Doc. No. BECO/ESR-1
SEPTEMBER 1984
REV. 1

Detailed Control Room Design Review

Executive Summary Report

Pilgrim Station

FIGURE 3-37. CONTAINMENT ISOLATION

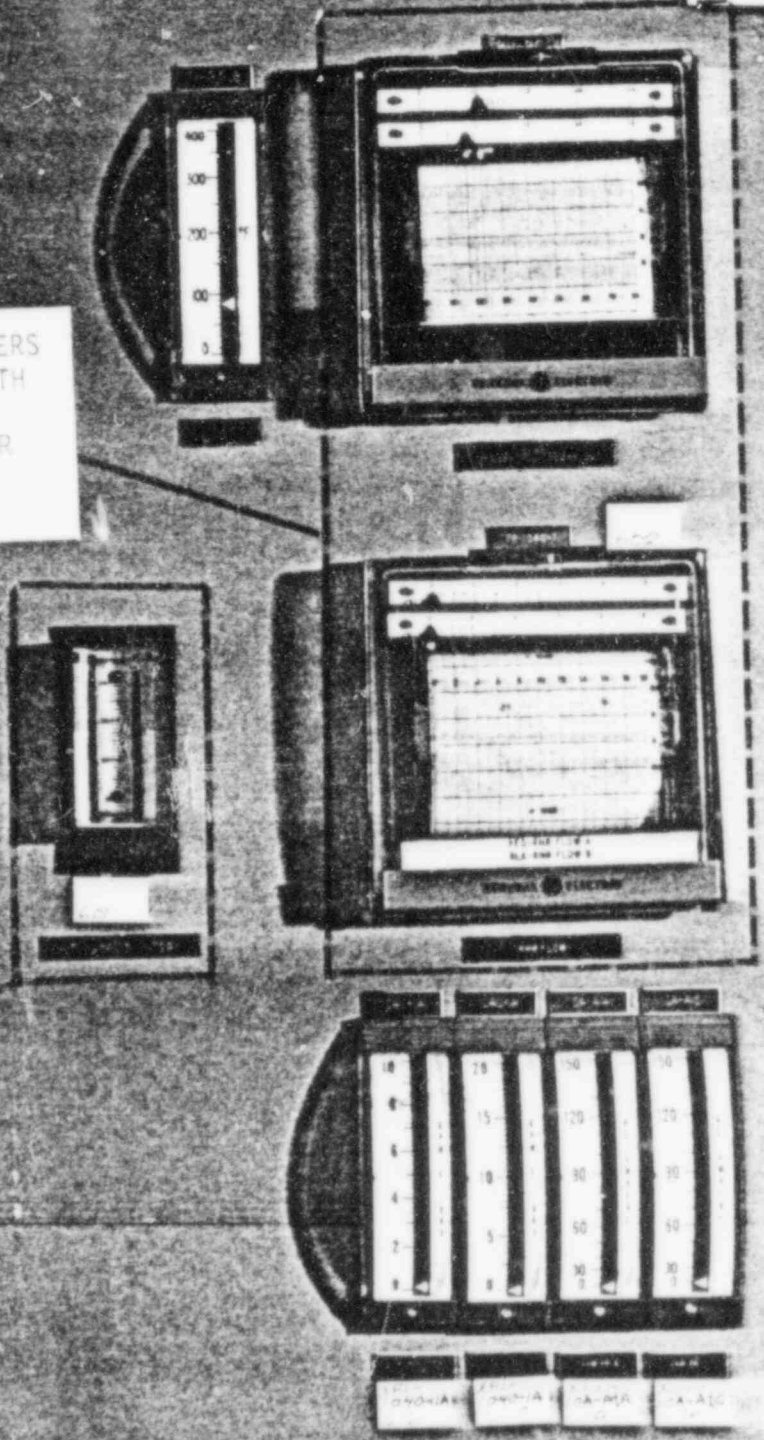
Figures 3-36 and 3-37 show containment purge and isolation monitoring. The mimic and valve position indication are part of the systems and equipment associated with HEDs 1A010.5, 1A011.5, 1B001.5, 8B102.5, and 5B119.5. These HEDs and solutions are discussed in Section 3.9.2 with the Water Cleanup Systems and Section 3.11 Augmented Off-Gas Panel CP600.

INTEGRATE INTO ARRANGEMENT WITH EQUIPMENT FROM C-7 CONTAINMENT PURGE AND TEST

FIGURE 3-42. AUTOMATIC BLOWDOWN SYSTEM RHR LOOP A SYSTEM

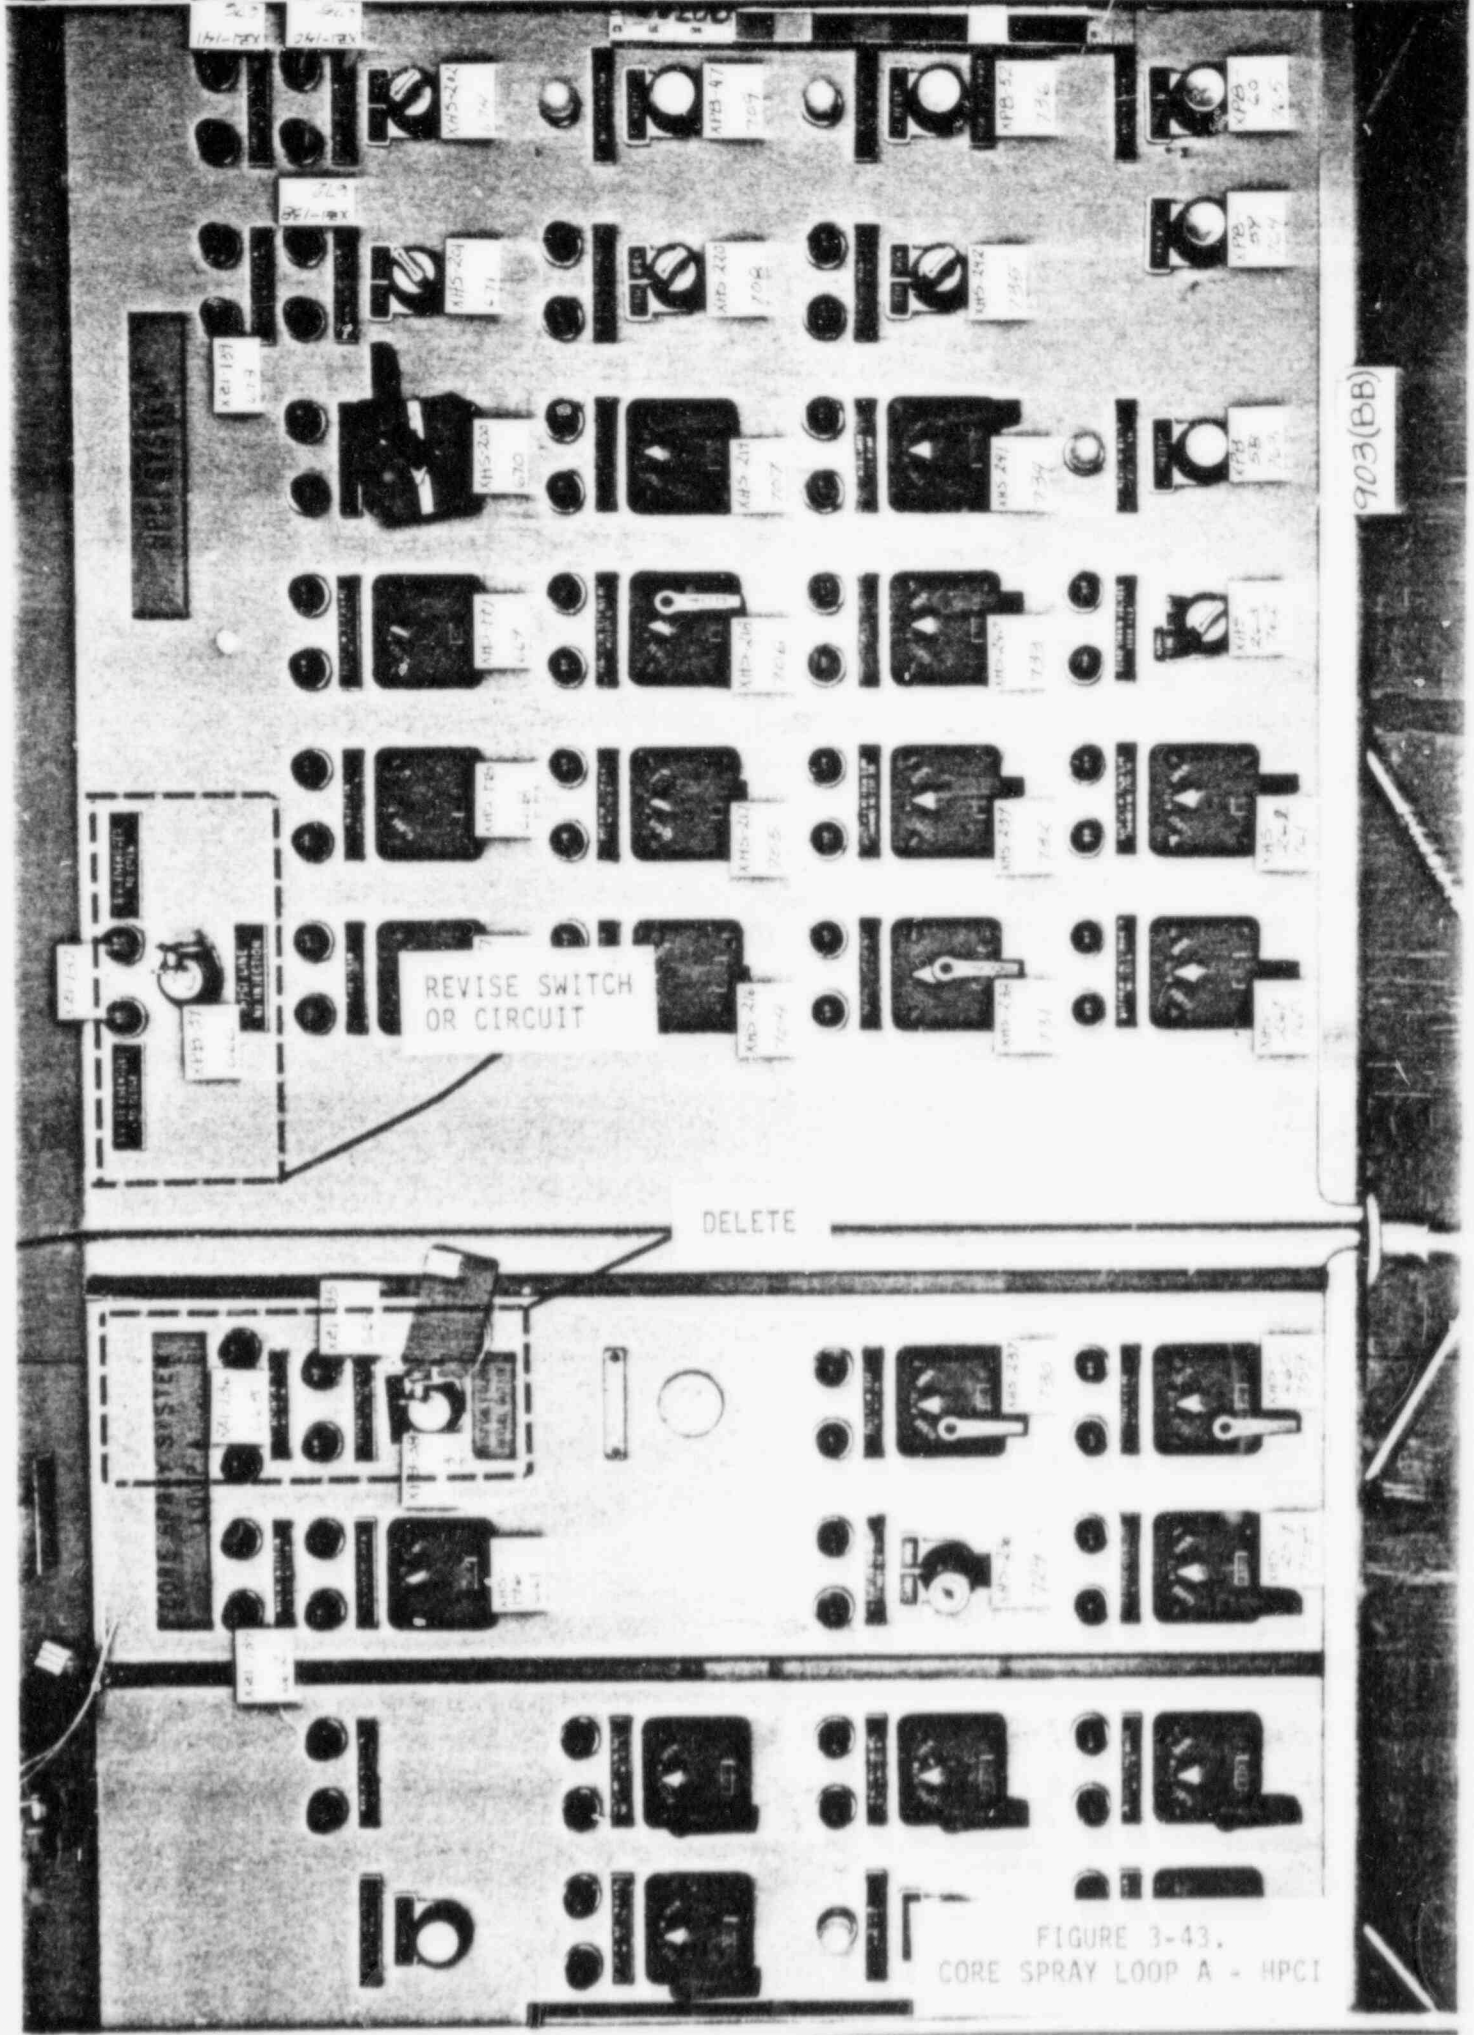
Figure 3-42 shows the automatic blowdown system controls associated with HED 8B124.5 as they are at present. The amber light for the relief valve manual controls have been abandoned. HED 8B103.5 requires that the two bottom controls (Nos. 750 and 751) be reversed.

Figures 3-42 and 3-44 show the RHR systems associated with HEDs 8B101.5 and 8B129.5 as they are at present. HED 8B101.5 requires the relocation of the RBCCW suction isolation valves for the RHR heat exchangers. The valve controls are presently located on the Feedwater and Condensate panel C1. HED 8B101.5 requires that the common suction isolation valves be located adjacent to each other. The equipment relocation is being evaluated for a complete rearrangement.

RELOCATE TO LOOP B

DELETE

REARRANGE TO BE SEQUENTIAL

FIGURE 3-43.
CORE SPRAY LOOP A - HPCI

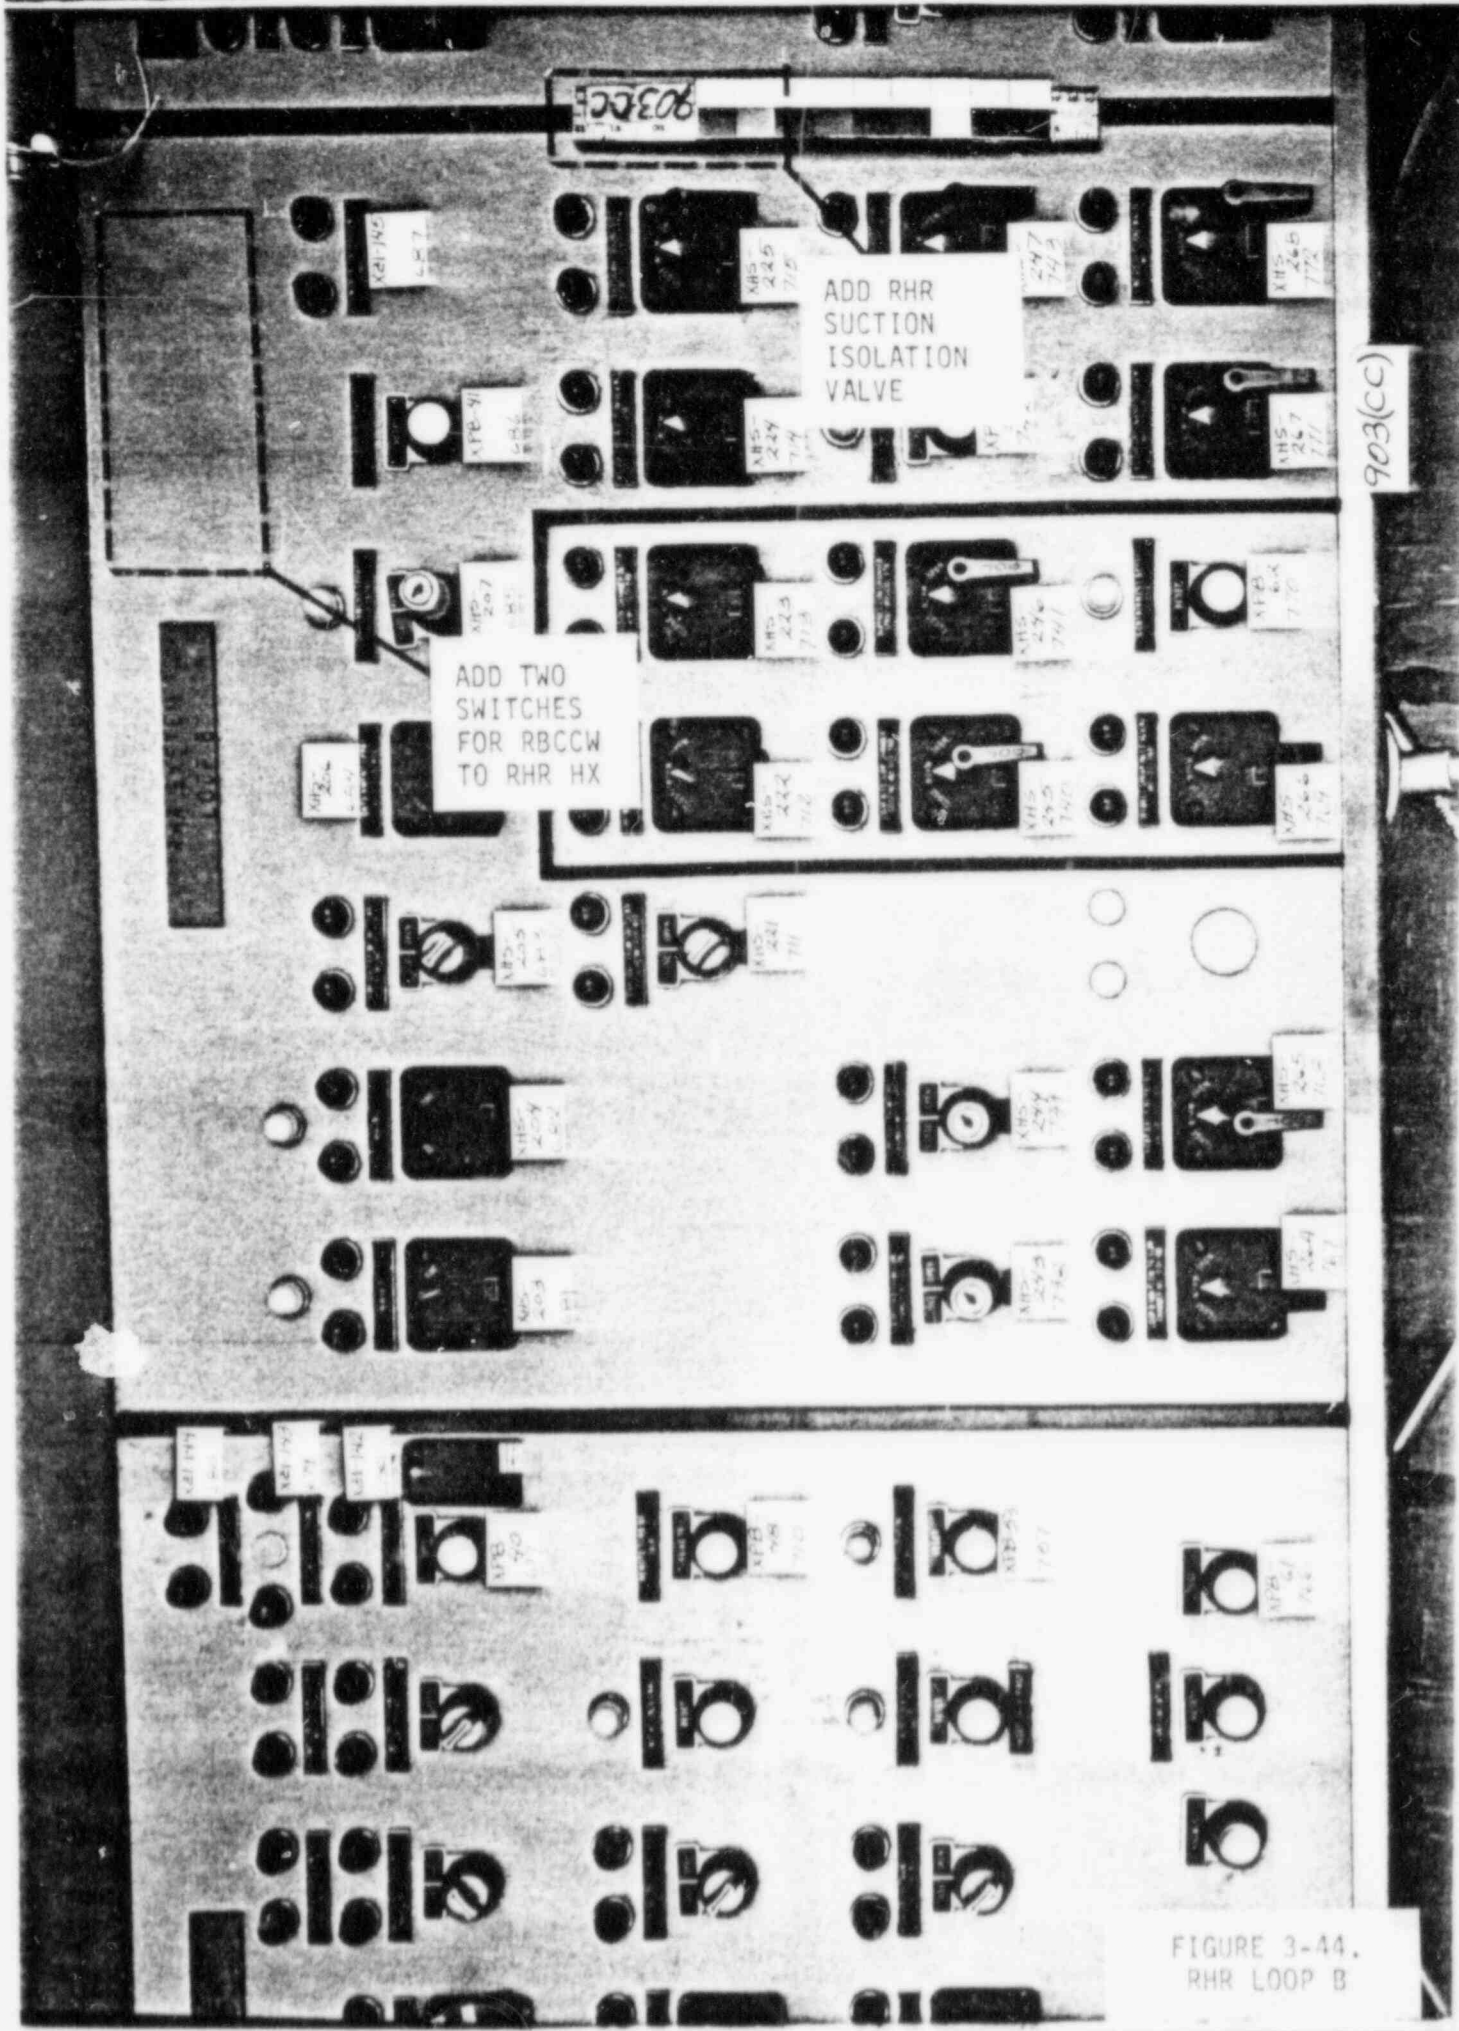
Figure 3-43 and 3-45 shows the core spray system loops A and B. HED 4B060.5 deletes the testable check valve controls.

Figure 3-43 shows the HPCI line nitrogen injection valve control associated with HED 4B115.5 as it is at present. Correction of the deficiency will require revising the switch or the control circuit.

FIGURE 3-56.
REACTOR CORE ISOLATION COOLING.

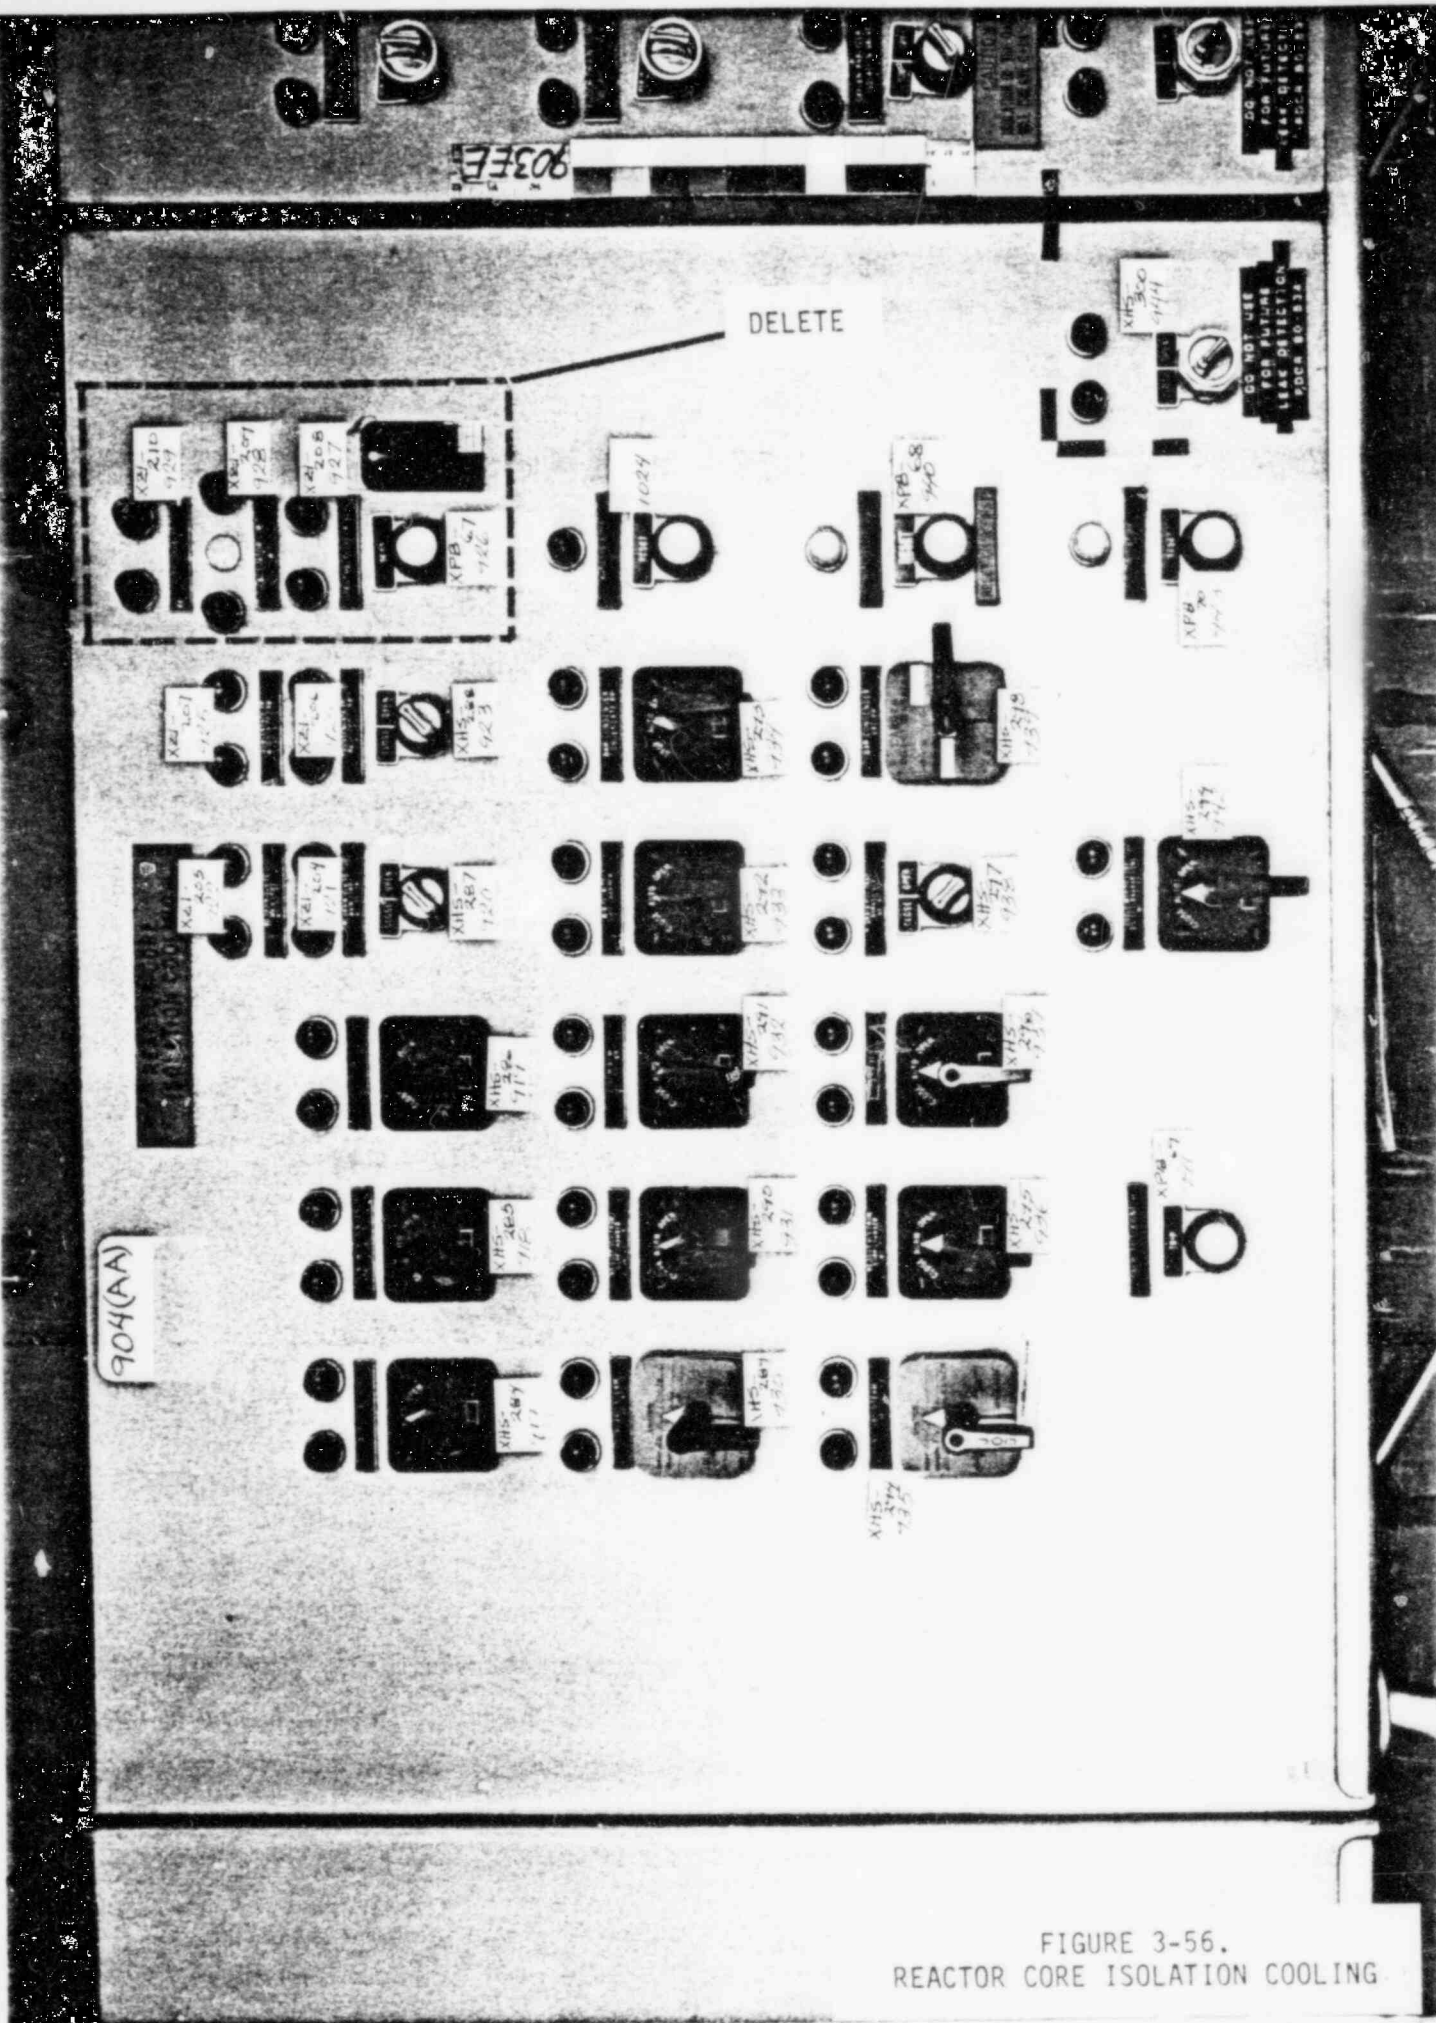
Figure 3-56 shows the RCIC system arrangement. The testable check valve controls have been deleted by HED 4B060.5.
